STAFF REPORT

APPLICATION NUMBER RZ 80-P-030

Applicant: Gerald Waldman

Proposed Use: Residential

RE ZONING APPLICATION

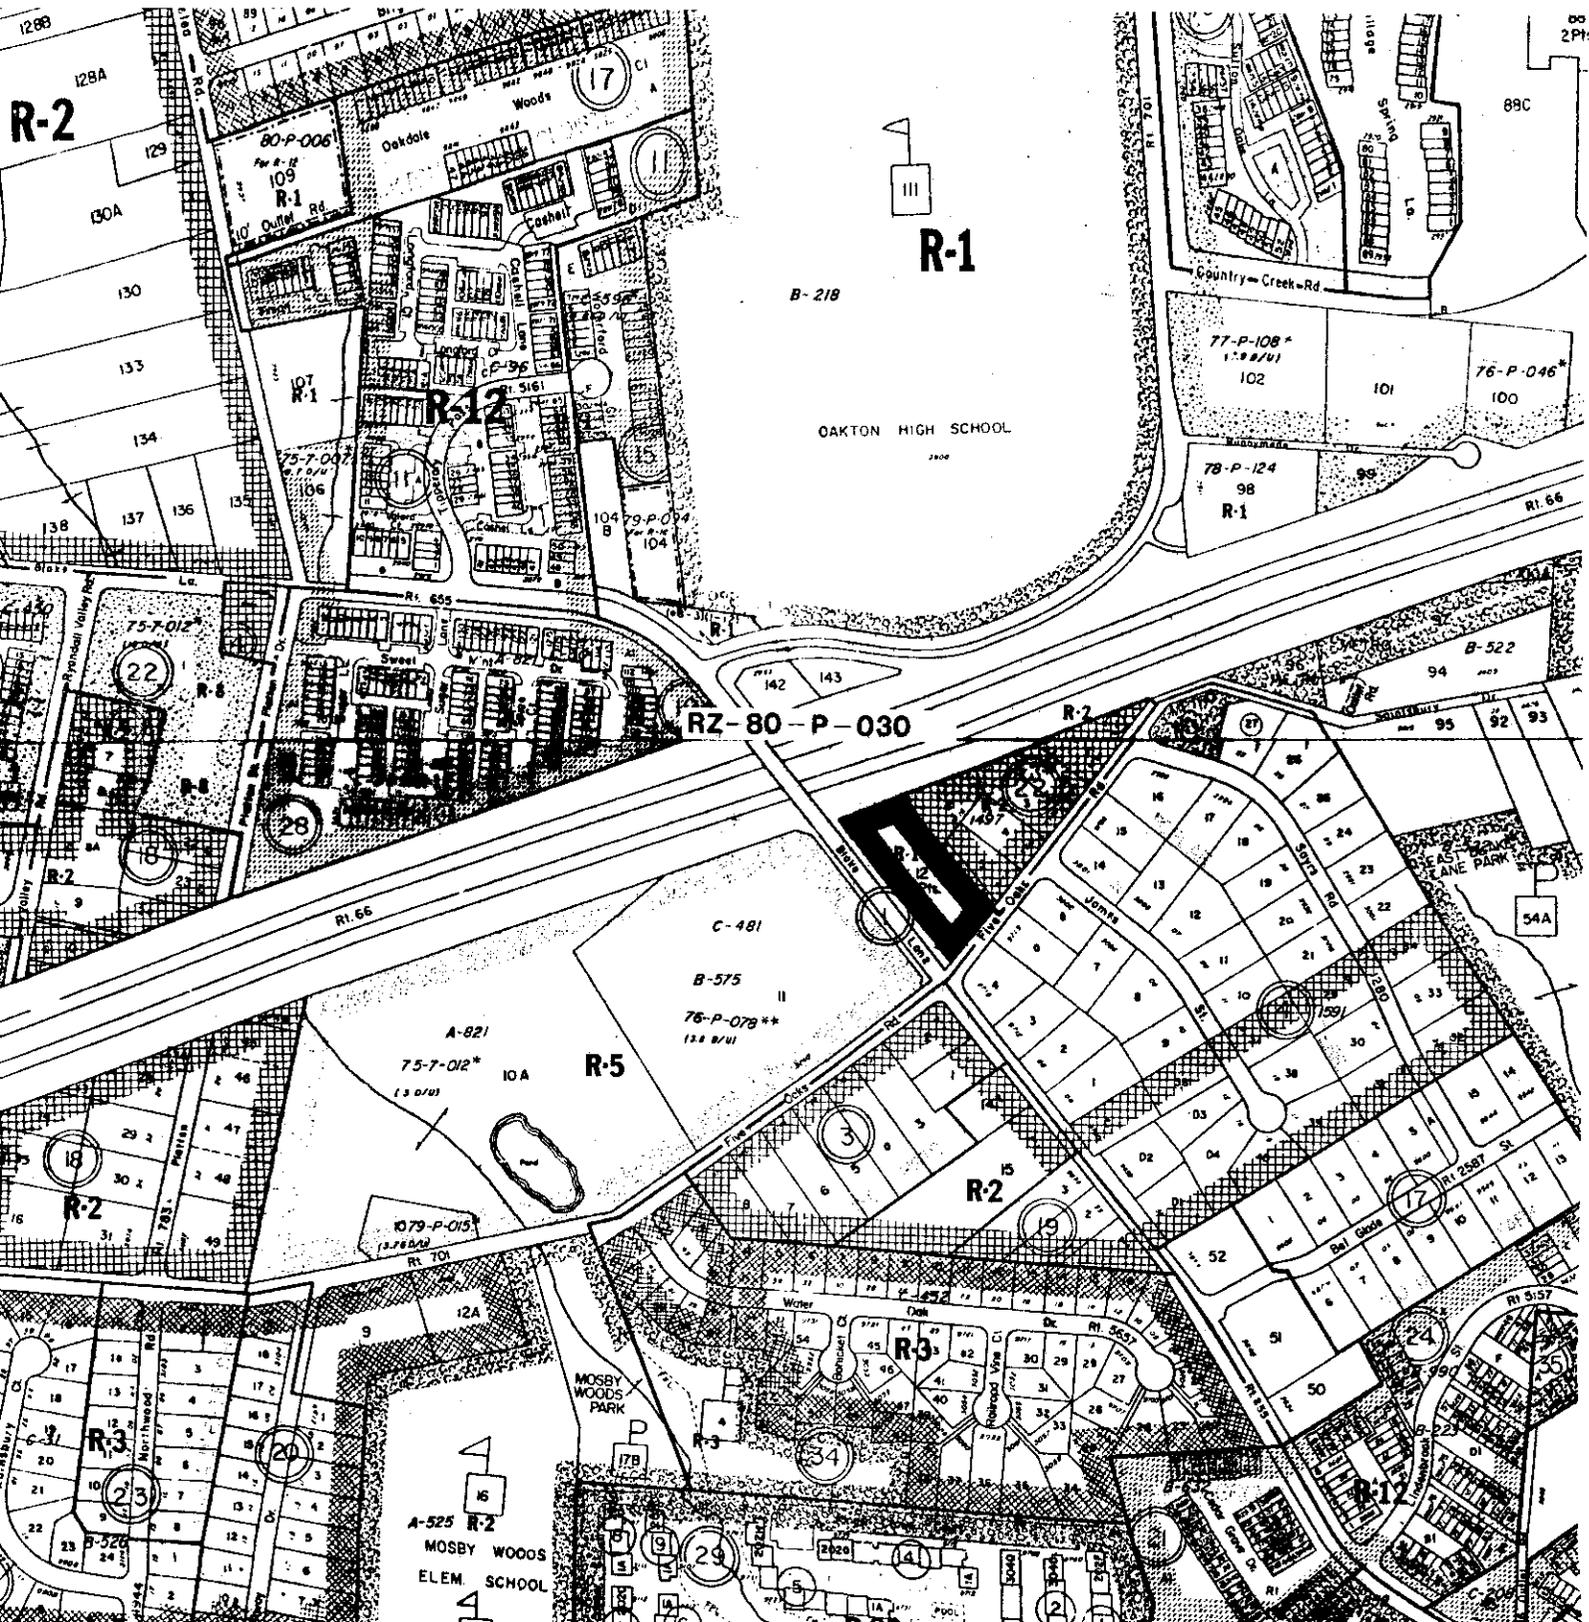
The proposed plat shows the property subdivided into four lots, a density of 2.39 du/ac. Blake Lane provides direct road access to all of the lots. Lot 4 is a corner lot which can also gain access to Five Oaks Road.

Pursuant to Sect. 2-414 of the Zoning Ordinance, a minimum distance of 200 feet must be maintained between all residential buildings and interstate highway rights-of-way. Half of the property lies within 200 feet of the right-of-way of I-66. Deviations from the Ordinance requirement may be permitted with Board of Supervisor approval of appropriate proffered conditions if such deviations will further the intent of the Comprehensive Plan, the Zoning Ordinance or other adopted policies. The Plan language recognizes the adverse impacts associated with significant levels of highway noise from I-66. The provision of acoustical treatment for all residential units within the 200 foot setback/noise impact zone and the construction of a solid acoustical fence six feet in height to protect the rear yard area of the affected residences would be appropriate as a means of allowing residential development within the otherwise restricted area. Noise attenuation measures would be necessary for the area identified as lots 1 and 2. The applicant has indicated a willingness to provide noise attenuation measures.

As the transportation analysis in Appendix 9 indicates, direct access to Blake Lane should be avoided. Construction of a private drive along the northeastern boundary of the property from Five Oaks Road to Lot 4 would eliminate direct access to Blake Lane.

4. Traffic impacts along Blake Lane from the proposed development could be reduced if access to the four lots was provided via Five Oaks Road. Dedication of right-of-way to 30 feet from centerline on Five Oaks Road would allow for future Plan recommended improvements.
7. Tree preservation is proposed. However there is no indication as to the location of extent of such preservation.

2. Develop the property with a maximum of four lots, a density of 2.4 du/ac.
3. Provide vehicular access to all lots via Five Oaks Road. No direct access shall be maintained to Blake Lane.

4. On Blake Lane dedicate right-of-way to forty five feet from centerline.
5. On Five Oaks Lane dedicate right-of-way to thirty feet from centerline.

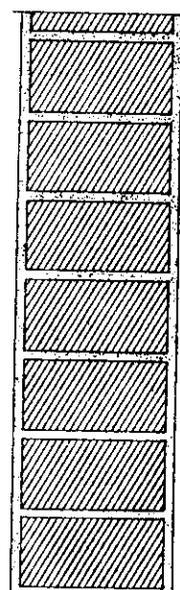
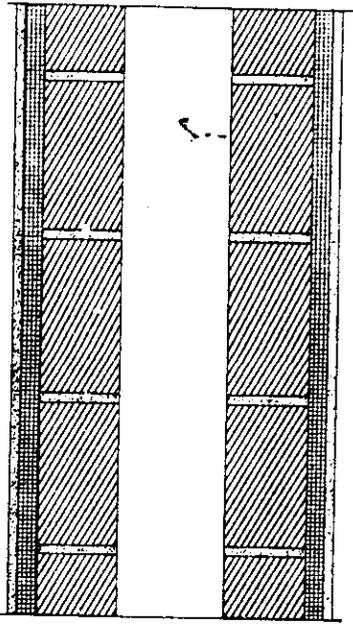
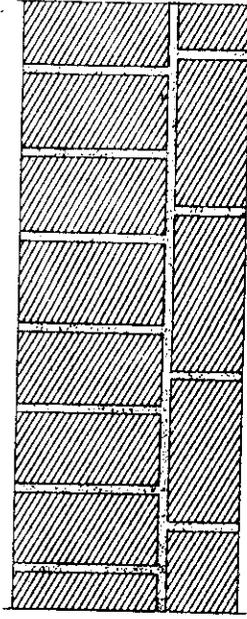
1. Exterior walls exposed to the traffic source (usually 3 of 4) should have a sound transmission class (STC) of not less than 50. Figures 1 and 2 show STC for several wall types. STC's for these materials is partially additive. For instance, a 4-inch brick wall (STC=40) used in conjunction with a common stud wall (STC=35) would achieve an STC of 50+.
2. Doors exposed to traffic noise shall have an STC of not less than 37.
3. The proportion of windows to interior wall area shall be not more than 15% for walls exposed to the highway noise source.
4. Rear yards should be enclosed by a 6 foot solid privacy fence.

- a. Exterior walls exposed to highway noise shall have an STC of not less than 50;
 - b. Doors shall have an STC of not less than 37;
 - c. The proportion of windows to interior wall area shall be no more than 15% for walls exposed to highway noise;
